September 26, 2025

ADDENDUM NO. 2

DNR-250004 GREAT COUNCIL OBSERVATION TOWER

C200

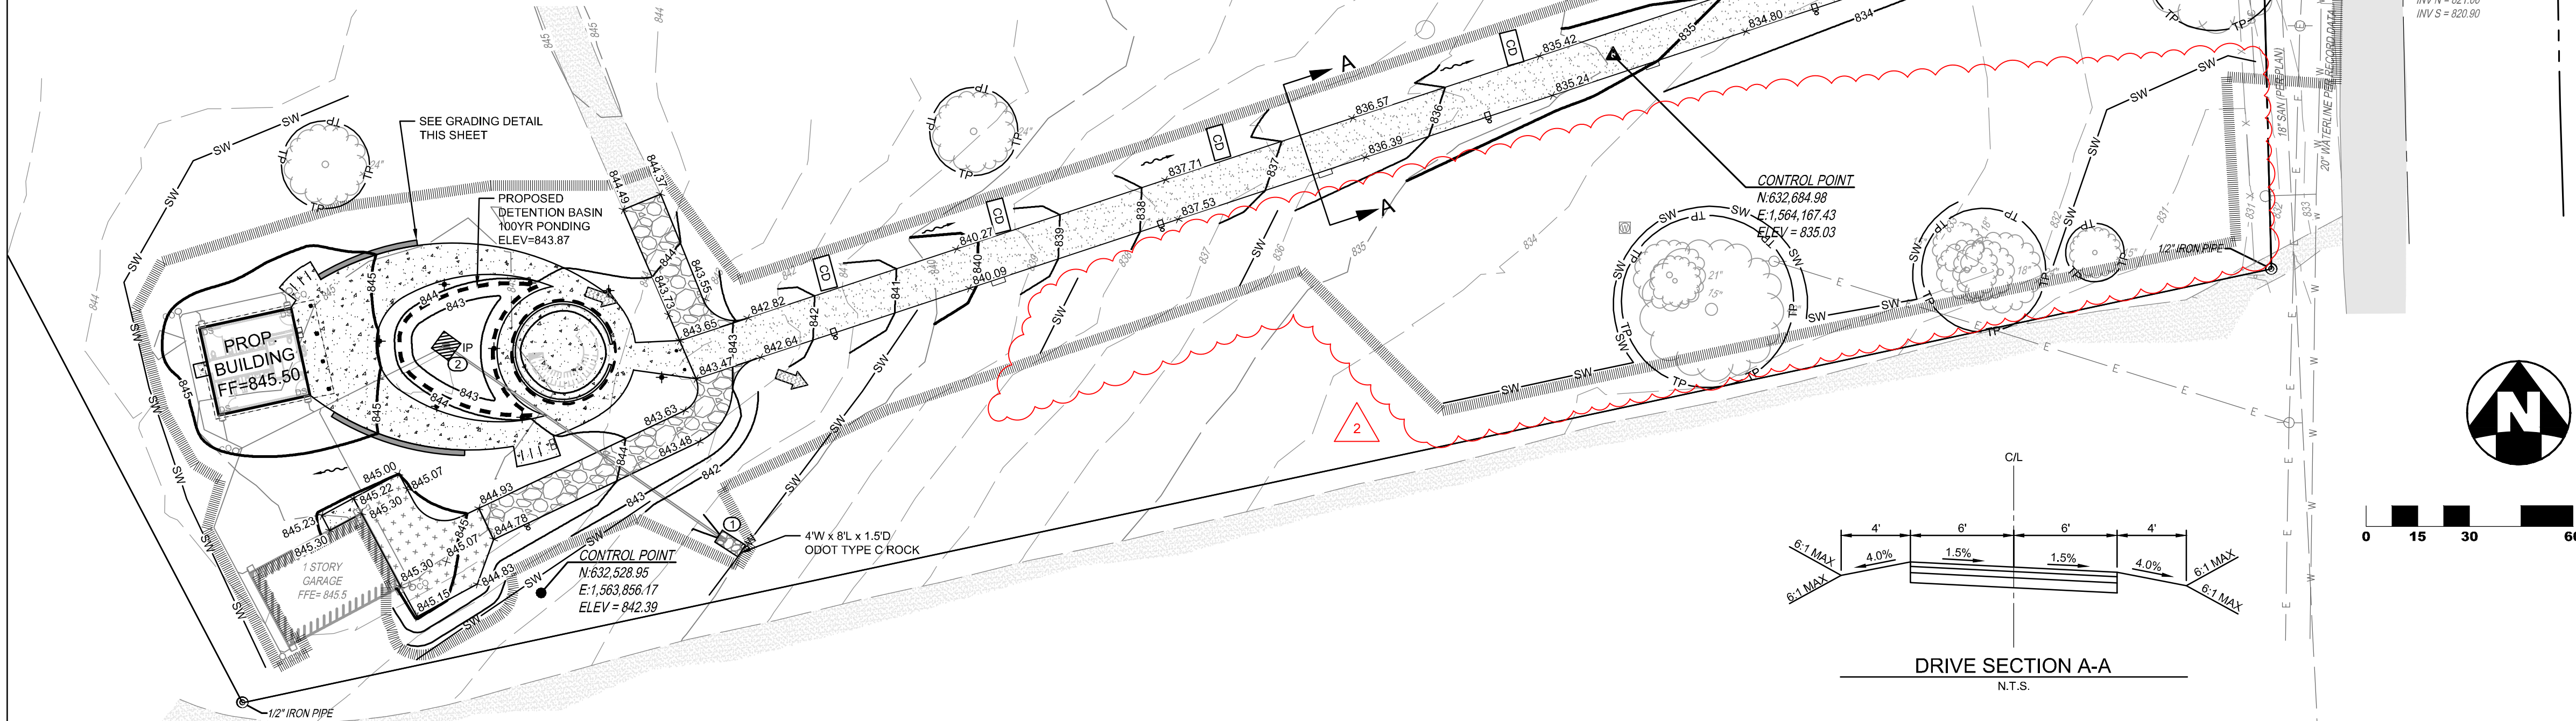
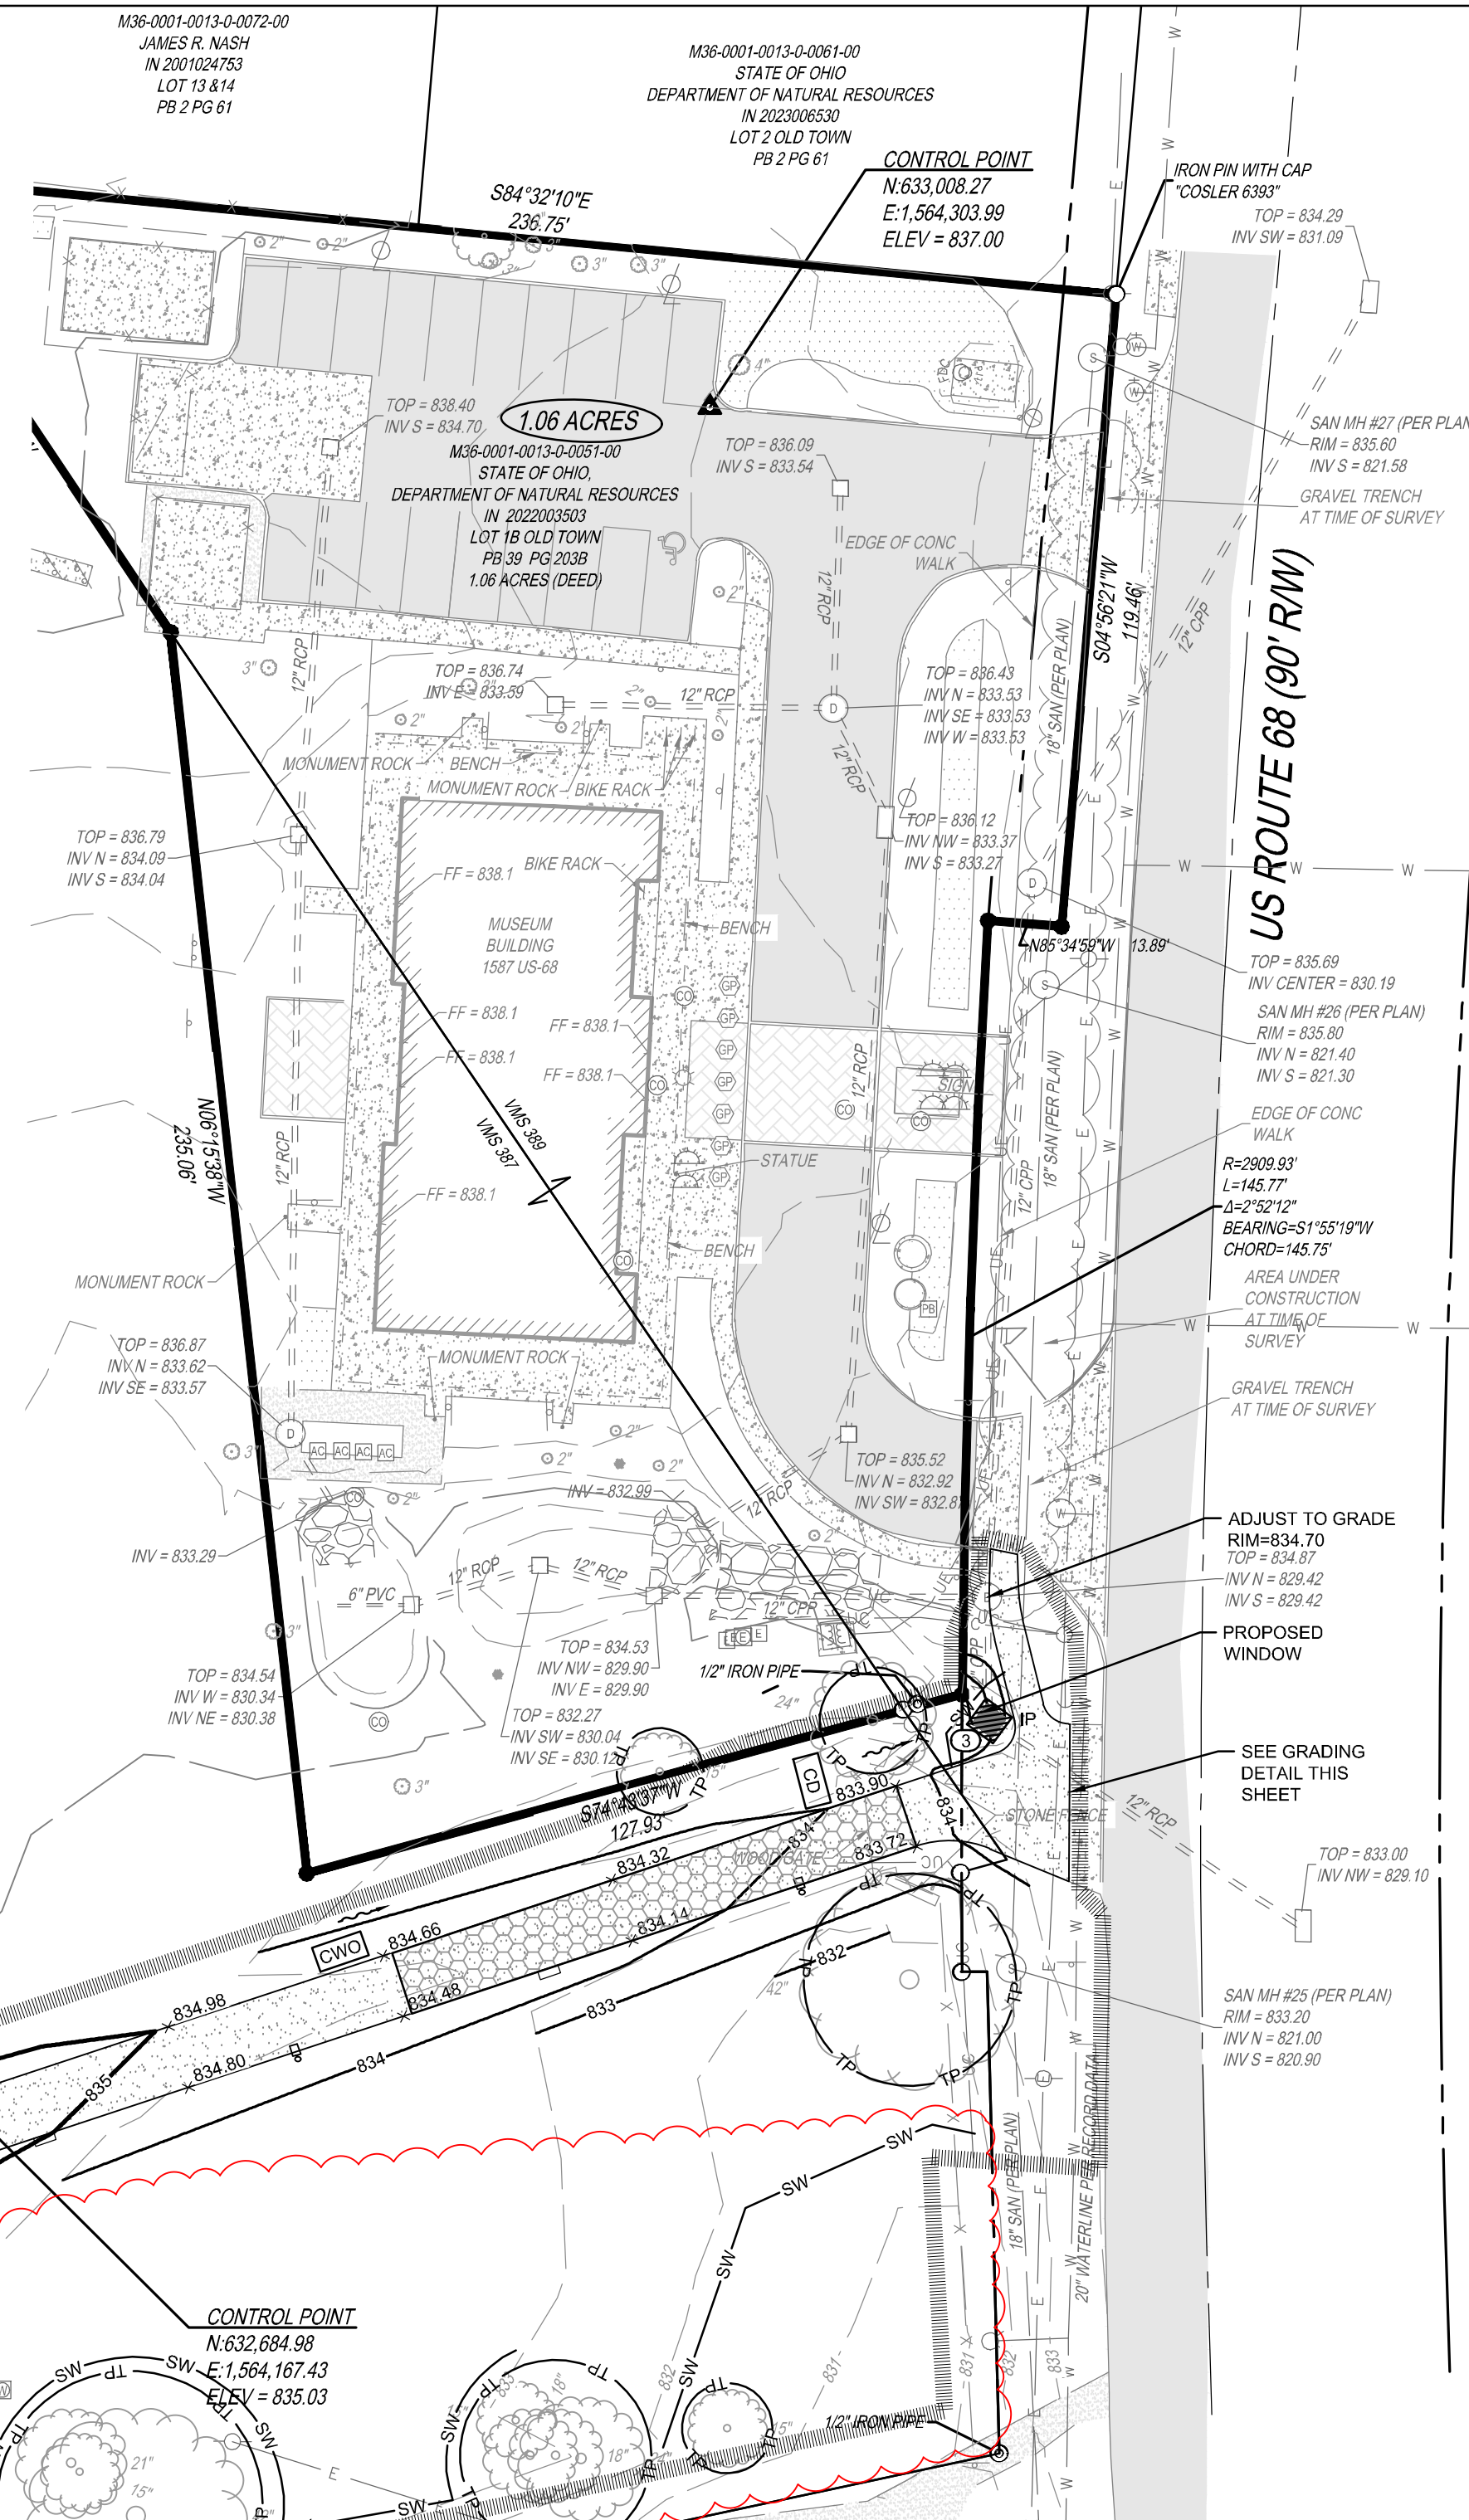
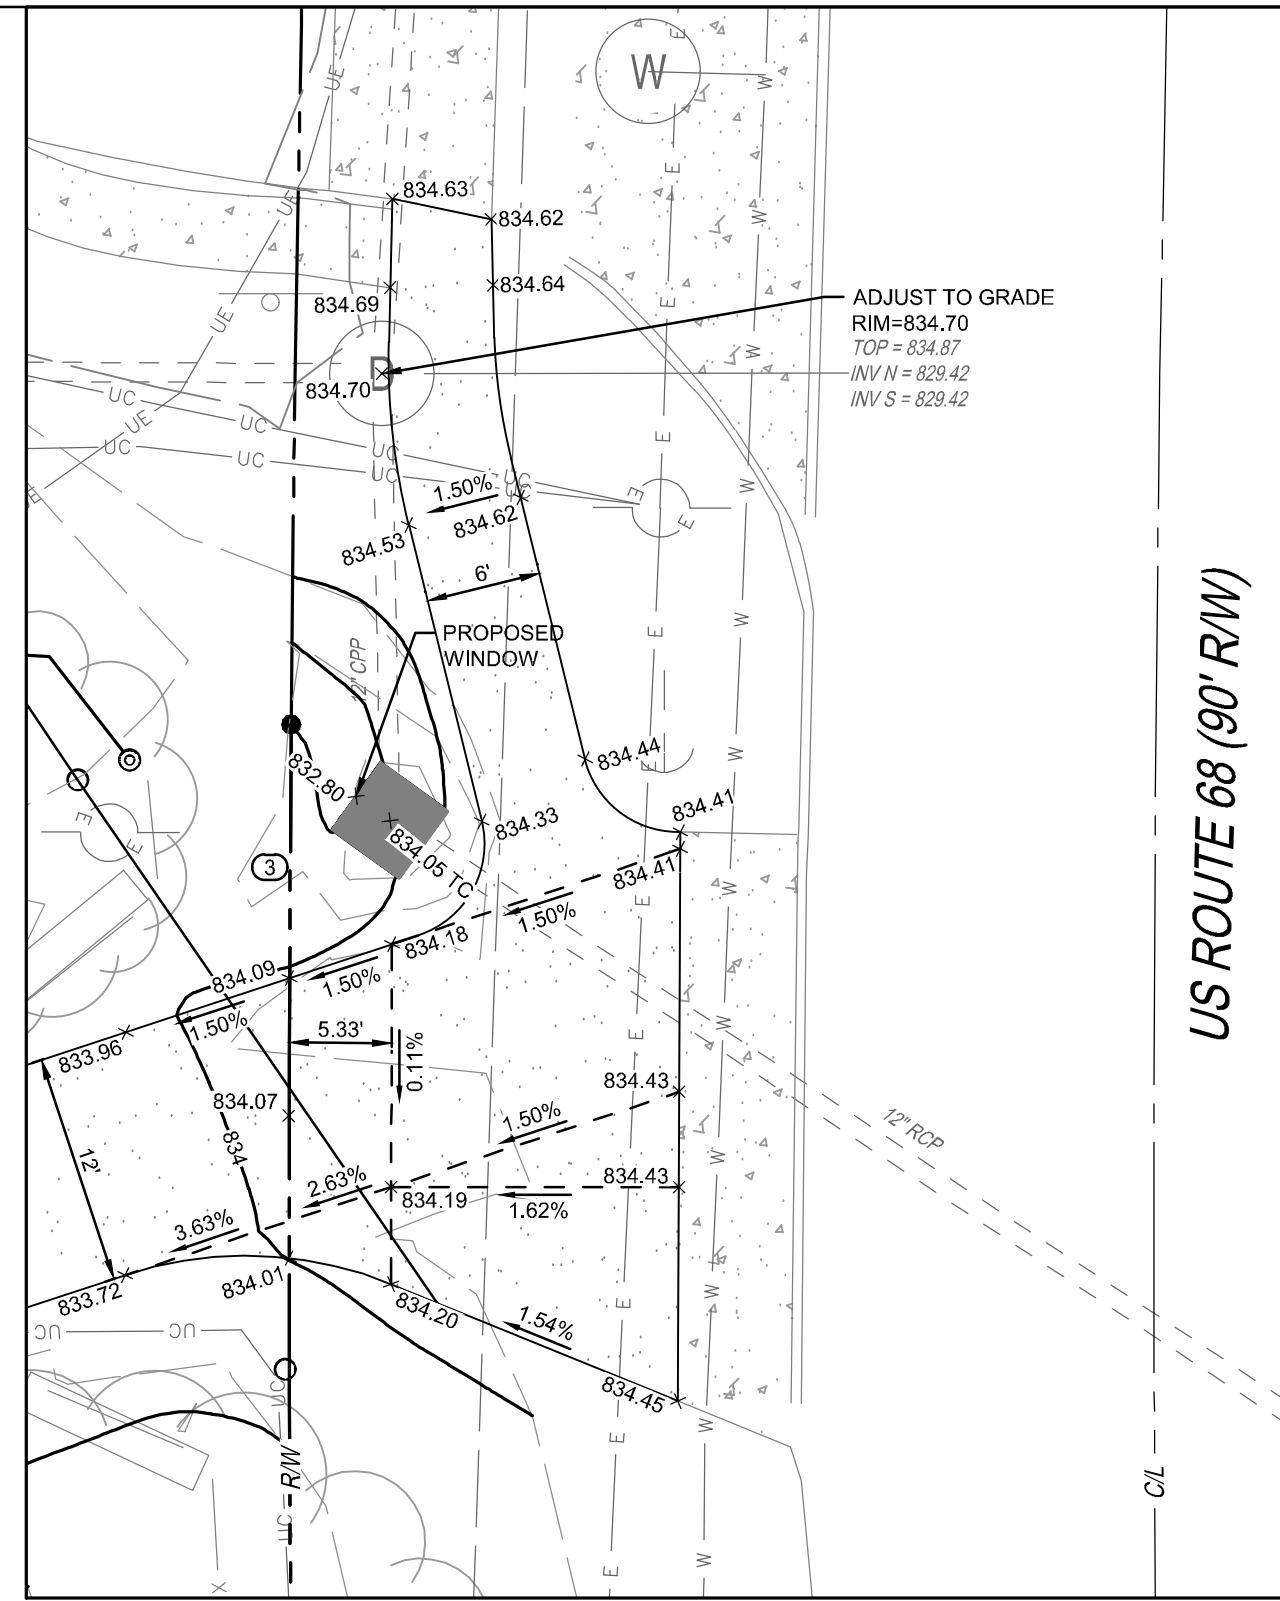
ITEM 6 C200 – GRADING AND EROSION CONTROL

Revised project limits to include laydown area and contractor parking.

Revised slope of concrete pad within tower footprint.

Revised concrete pavement extents around tower and detention basin.

8 SEAT WALL

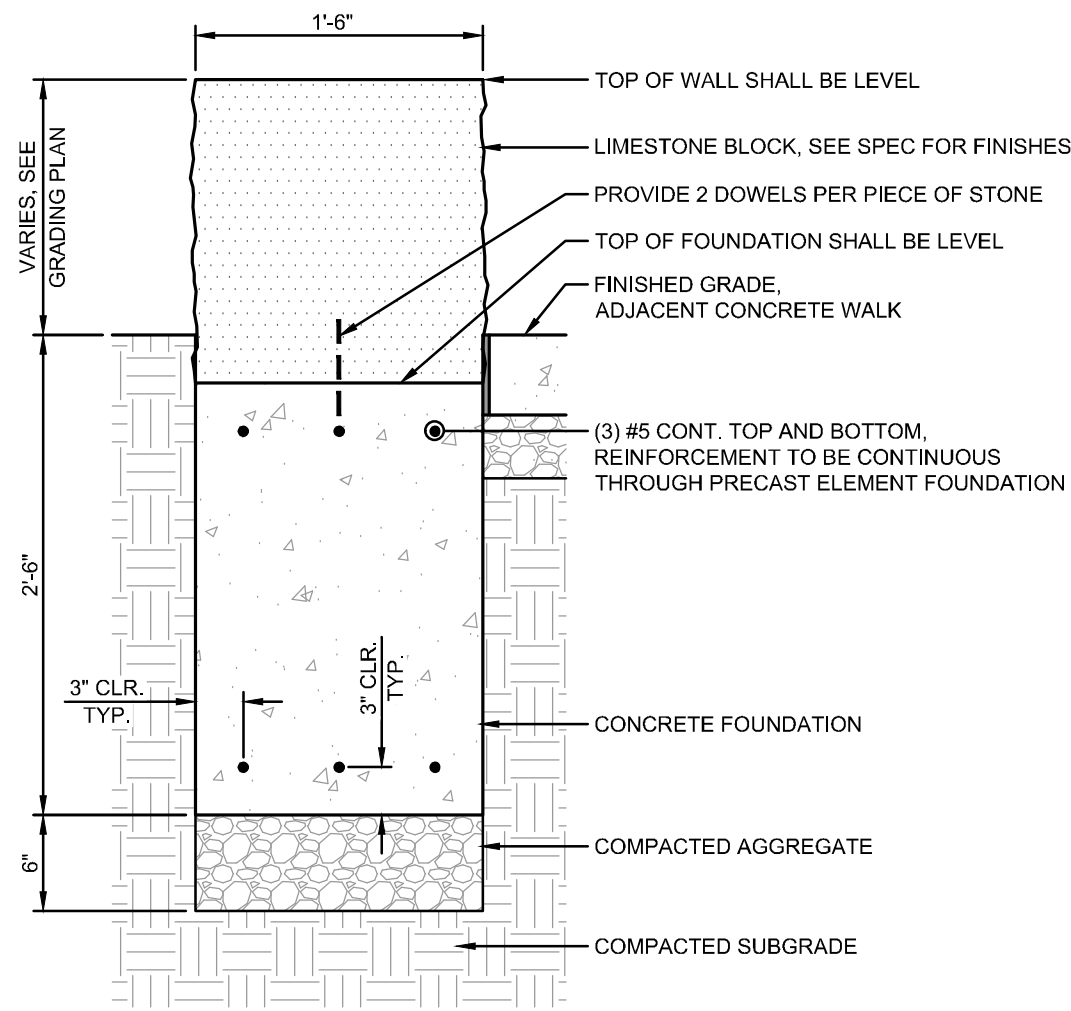
ITEM 7 L100 – SITE DETAILS

Revised radius of North and South seat walls.
